August 3, 1984

HOPE CREEK GENERATING STATION  
DOCKET NO. 50-354  
DRAFT SAFETY EVALUATION REPORT  
OPEN ITEM STATUS

In addition, enclosed for your review and approval (see Attachment 4) are the resolutions to the Draft SER open items, FSAR question responses and structural geotechnical audit item responses, listed in Attachment 3.

FIGURE A-16-5

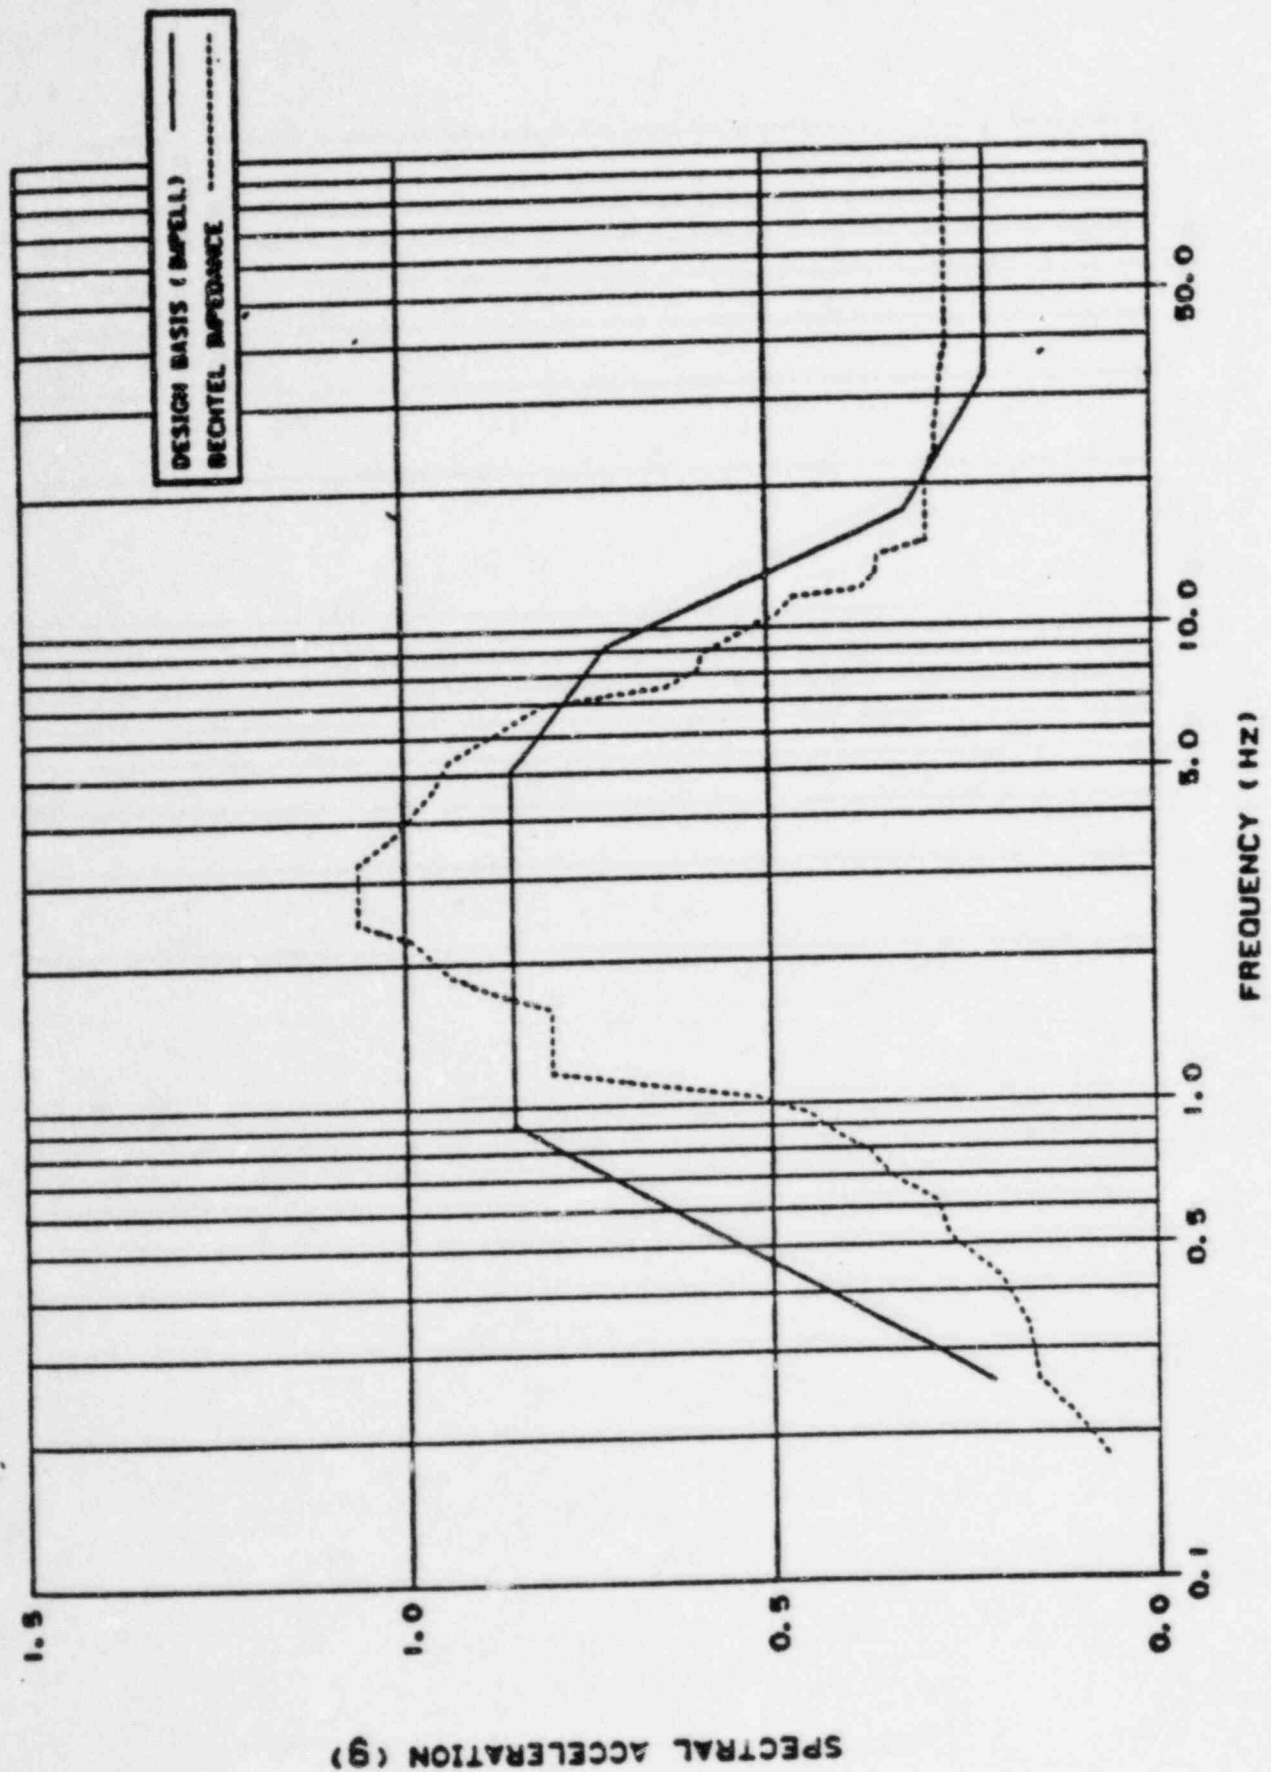
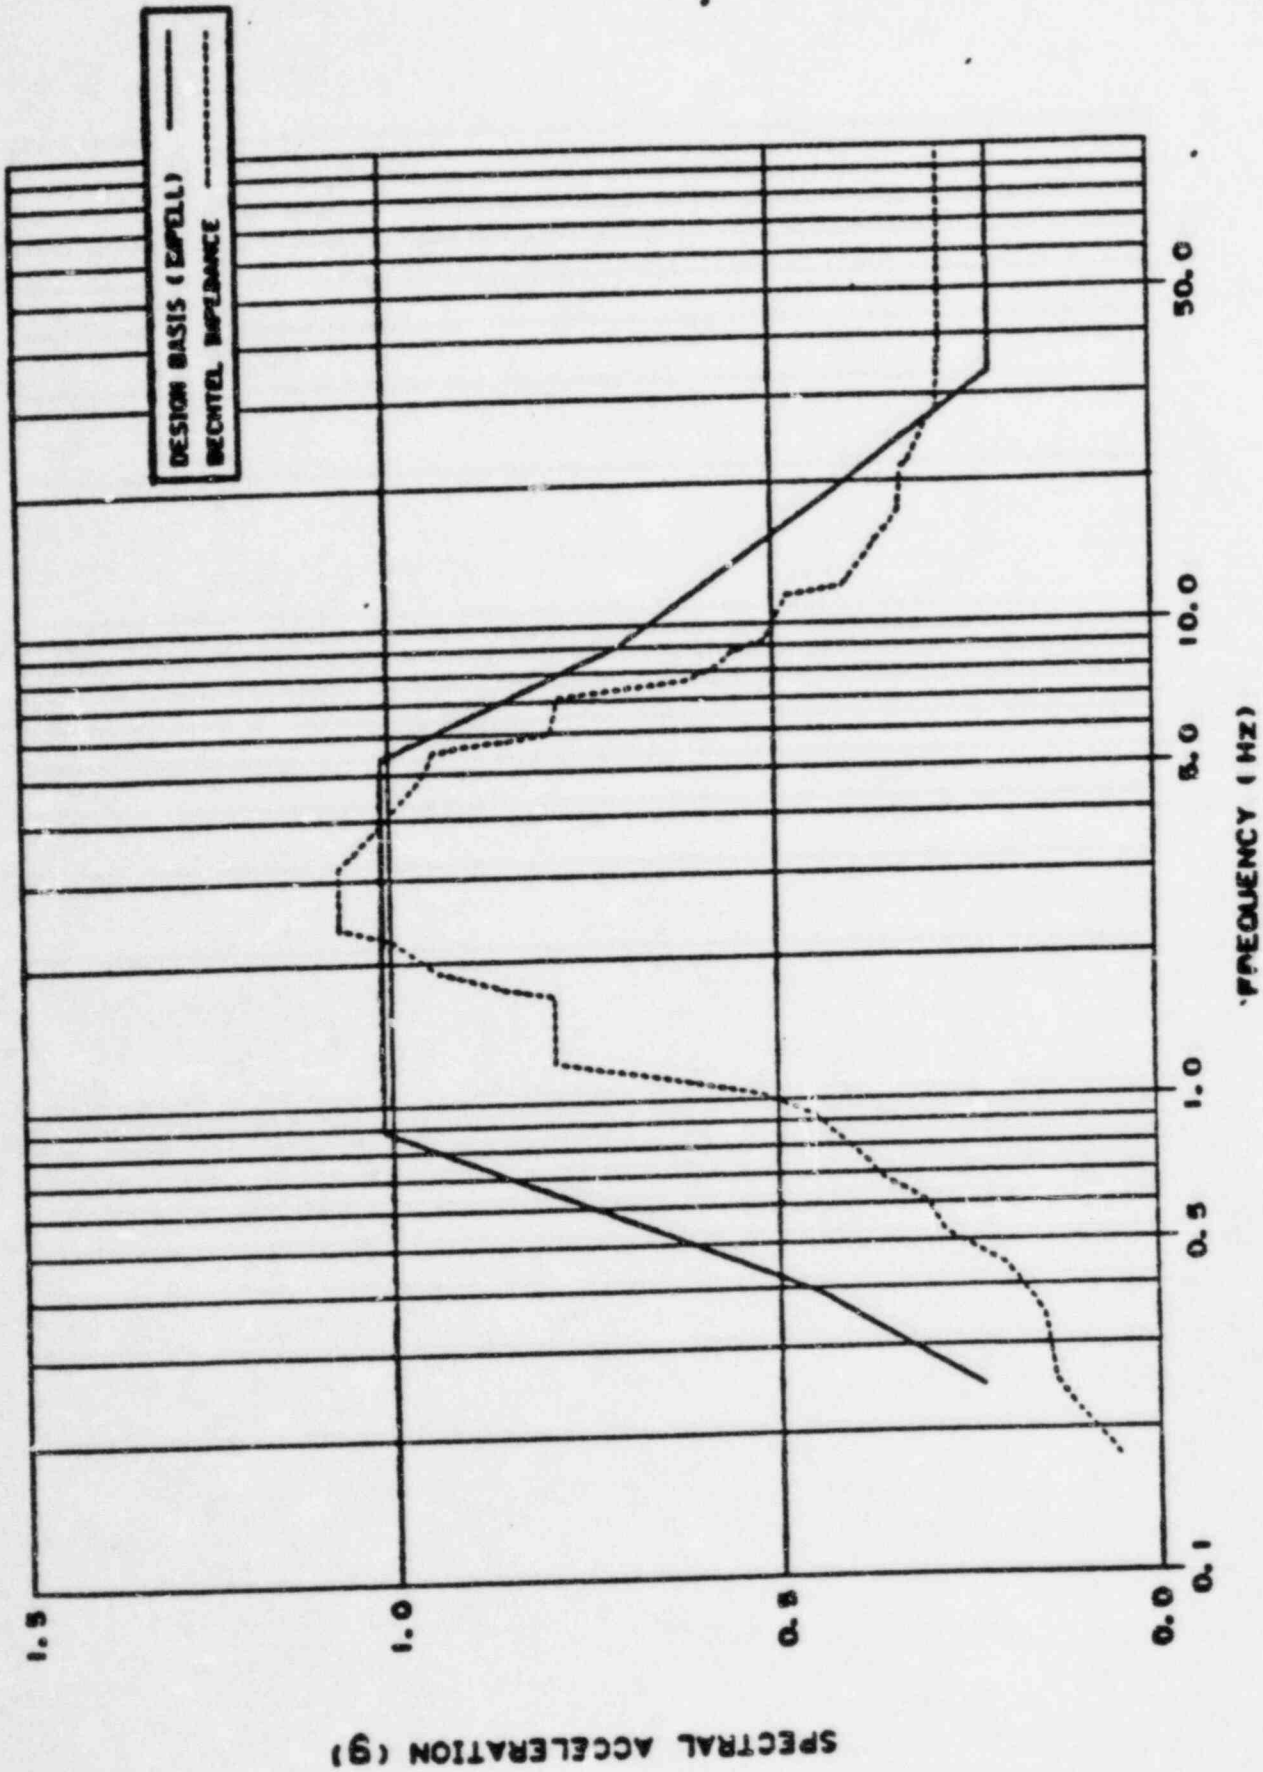
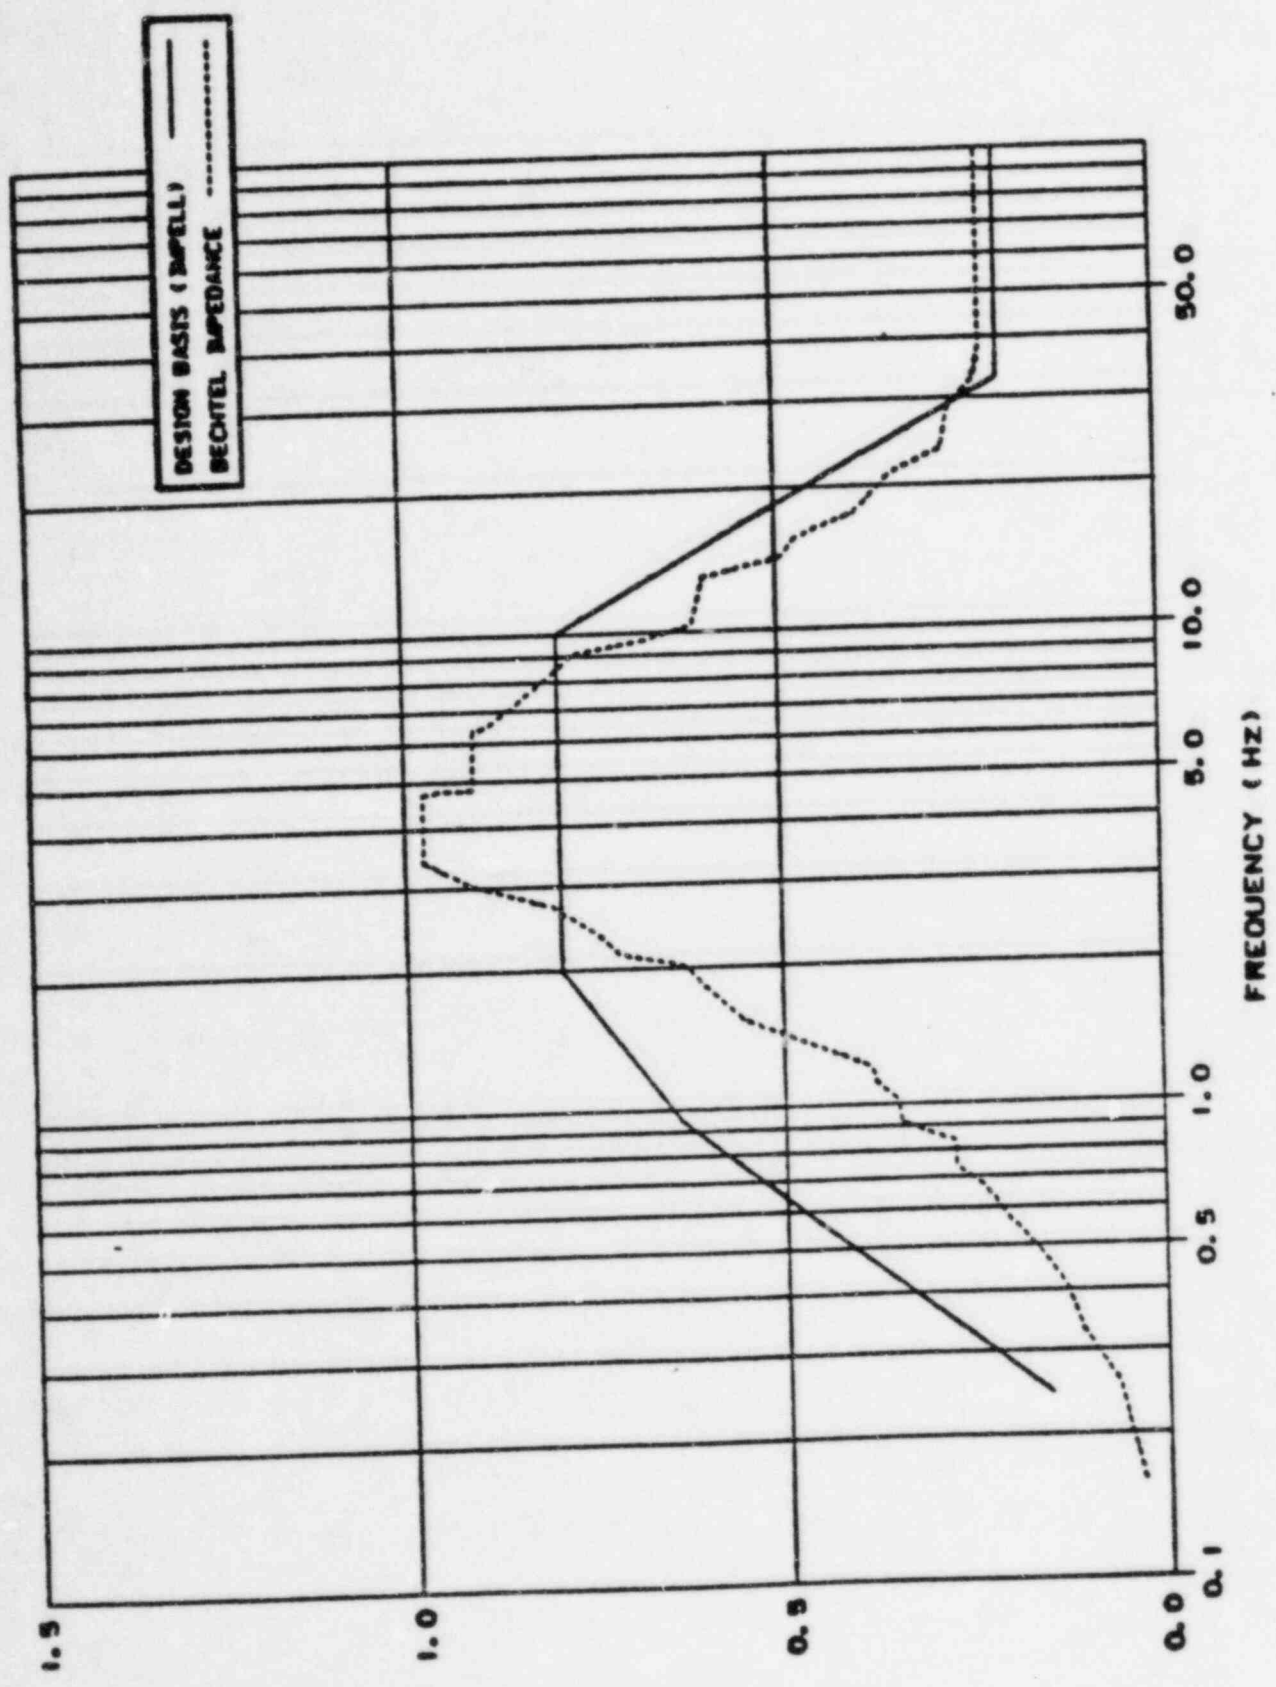
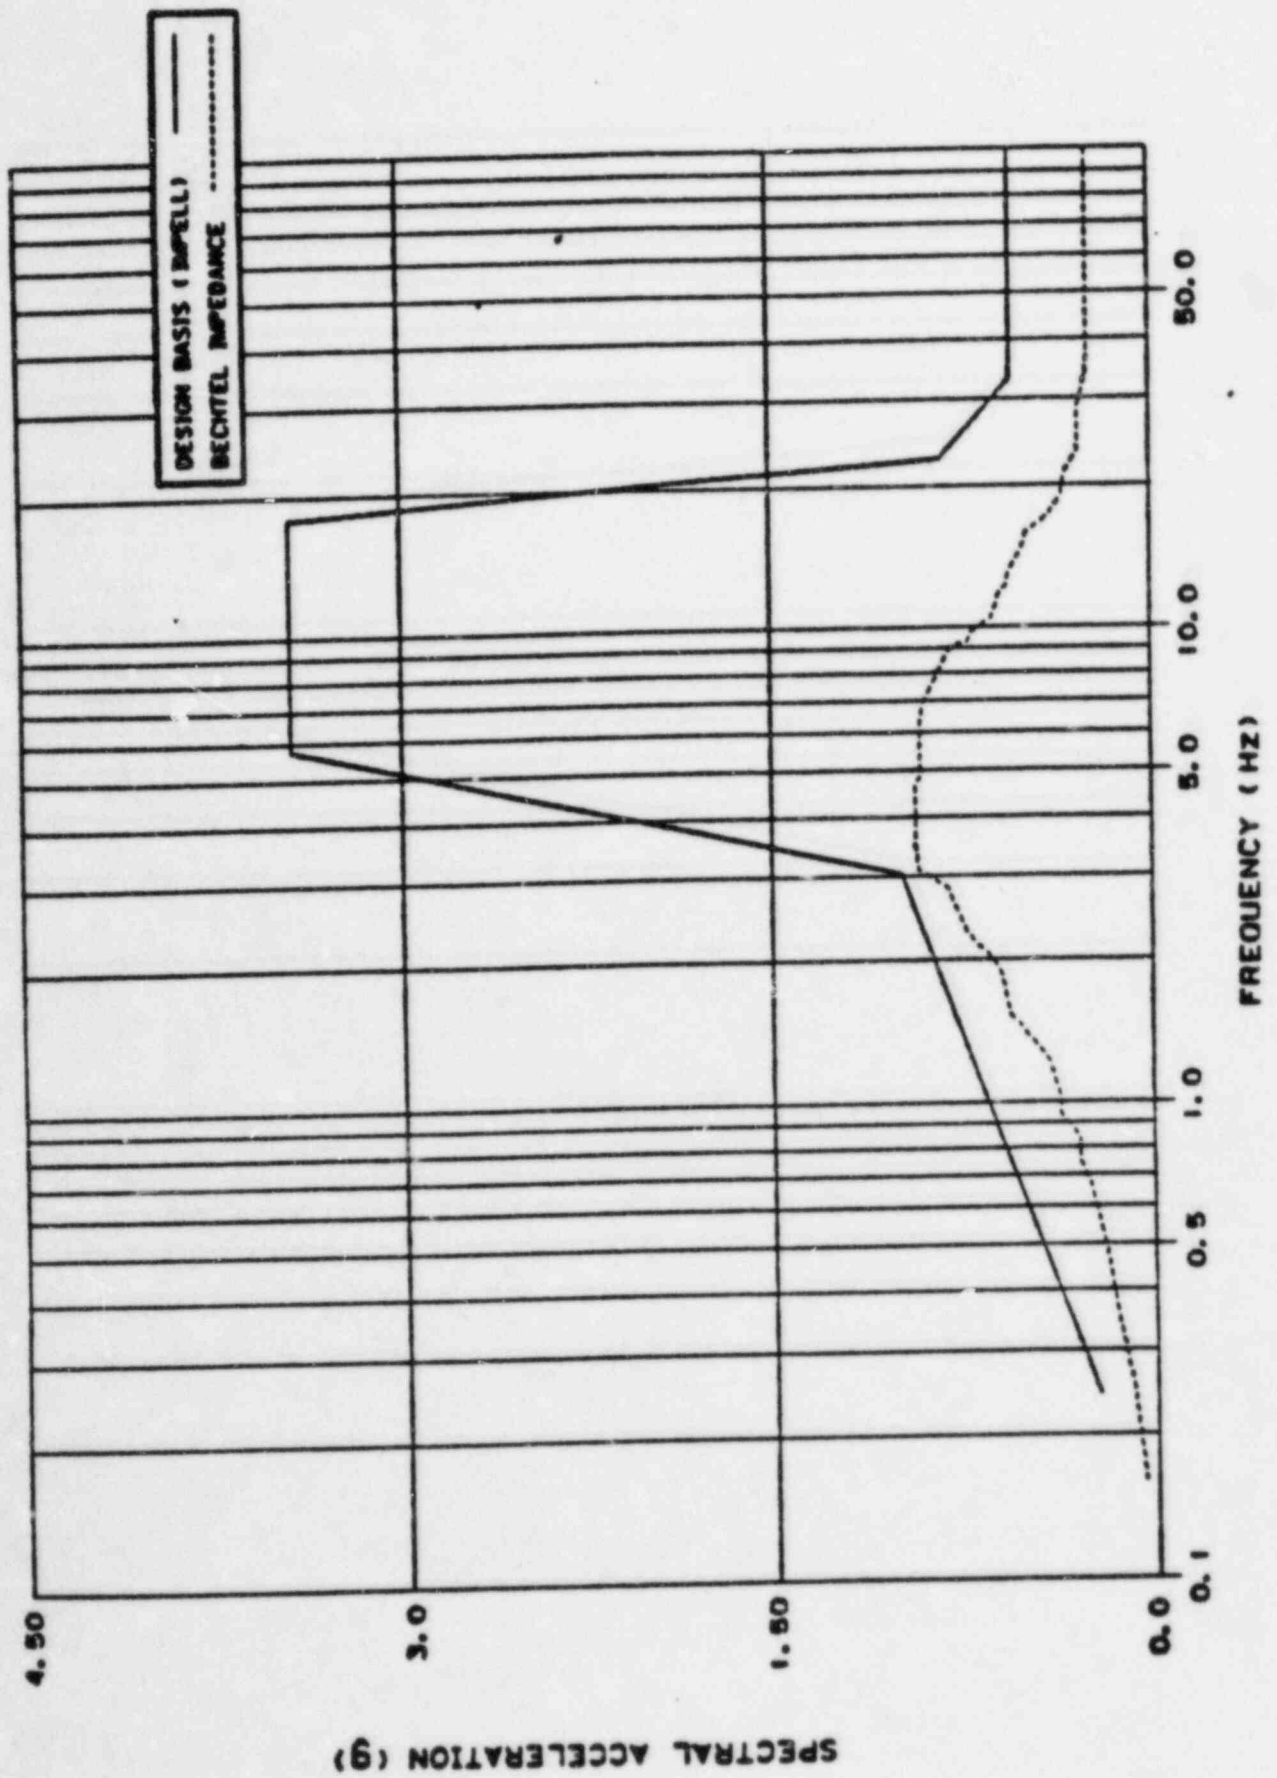
Response

Figures A-16-1 to A-16-18 show the comparison of the 2 percent damping response spectra obtained from the design basis finite element and the impedance approach seismic soil-structure interaction analyses. The impedance approach response spectra generally are enveloped by those obtained from the design basis analyses at elevation 114.0 feet of the SWIS. For other elevations, the impedance approach spectral accelerations exceed the design basis spectral accelerations in some frequency ranges. These ranges vary approximately between 1.5 and 10.0 Hz.
